Flight Procedures Cover Page	Task Action: Amendment	Task Type: SID	Estimated Chart Date: 11/03/2022	APWS Task ID: 68824B2FF2714518833B2C75A48F10E3	APWS Project ID: 762AACA672AA4EBFB4F1303ED36CA3D5
Procedure: SID JASPA SEVEN (RNAV) DALLAS-FORT WORTH KDFW		Enroute: YES	Specialist: Copeland, Guy		Agreement Number:
Airport ID: KDFW			Airport City: DALLAS-FORT WORTH		State: TX
Facility ID:	Facility Type:	Flight Inspection Remark Type:

Procedure Comments:
AMENDMENT

**Federal Aviation Administration
Categorical Exclusion Determination
Standard Instrument Departure Procedure Amendments at
Dallas Love Field and Dallas-Fort Worth International Airport, and
Standard Terminal Arrival Routes at Dallas-Fort Worth International Airport**

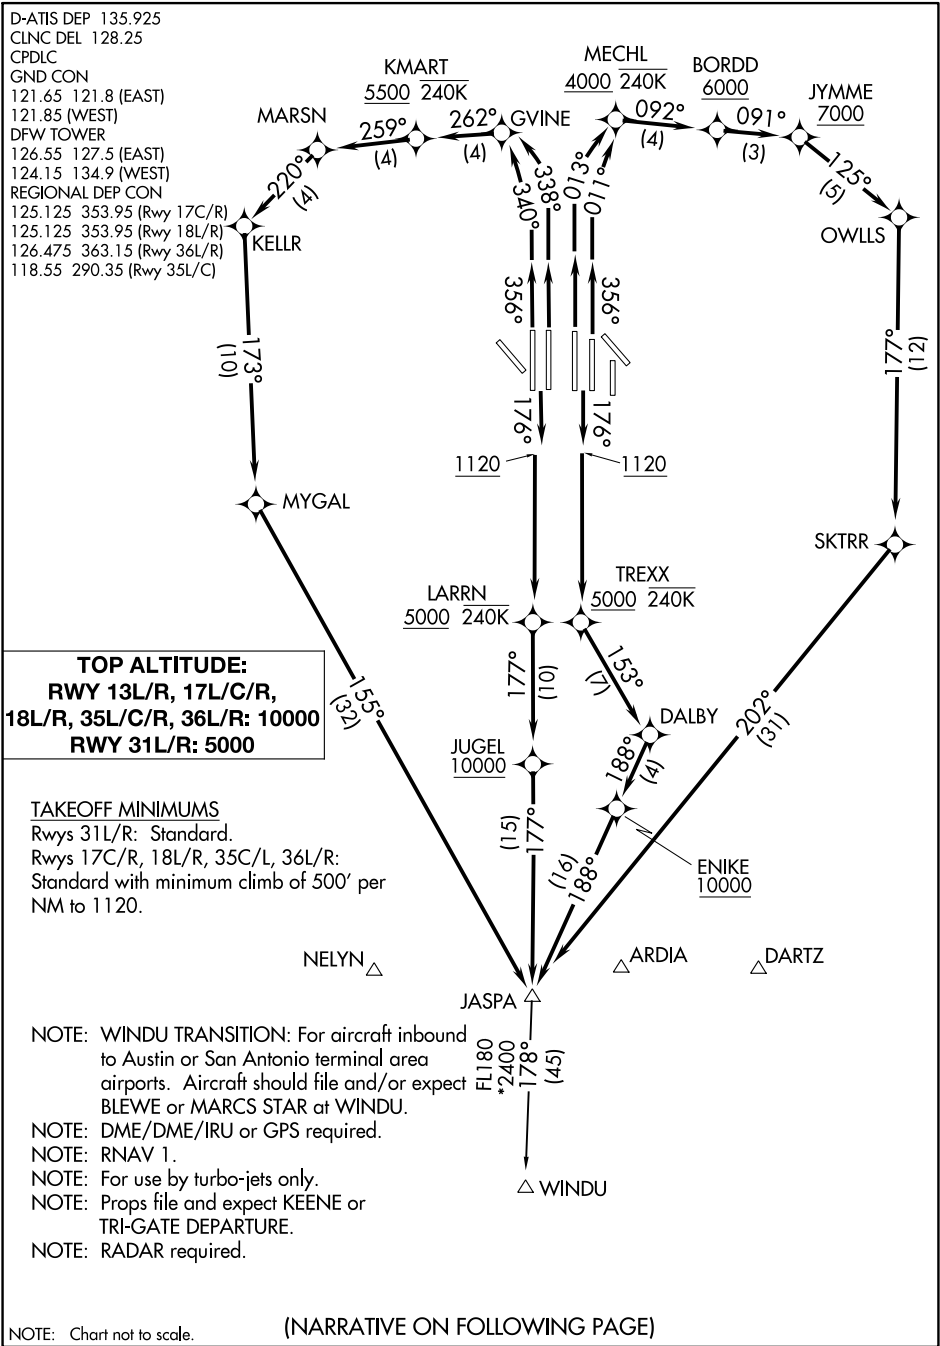
08/23/2022 THIS IS A CORRECTED COPY OF THE FORM APPROVED ON 07/14/2022:

1. REMOVED DUPLICATE ENTRY OF ...(TRANSITION) MAINTAIN 10000, EXPECT FILED ALTITUDE TEN MINUTES AFTER DEPARTURE FROM DP ROUTE DESCRIPTION
2. CHANGED WINDU TRANSITION COMPUTER CODE FROM JASPA7.JASPA TO JASPA7.WINDU
3. UPDATED TAKEOFF RWY 31L DEPARTURE ROUTE FROM CLIMB ON HEADING 315.05 OR AS ASSIGNED BY ATC, FOR VECTORS TO JASPA, THENCE... TO CLIMB ON HEADING 315.05 OR AS ASSIGNED BY ATC, FOR VECTORS TO JASPA, MAINTAIN 5000, EXPECT FILED ALTITUDE 10 MINUTES AFTER DEPARTURE.
4. UPDATED TAKEOFF RWY 31R DEPARTURE ROUTE FROM CLIMB ON HEADING 311.27 OR AS ASSIGNED BY ATC, FOR VECTORS TO JASPA, THENCE... TO CLIMB ON HEADING 311.27 OR AS ASSIGNED BY ATC, FOR VECTORS TO JASPA, MAINTAIN 5000, EXPECT FILED ALTITUDE 10 MINUTES AFTER DEPARTURE.
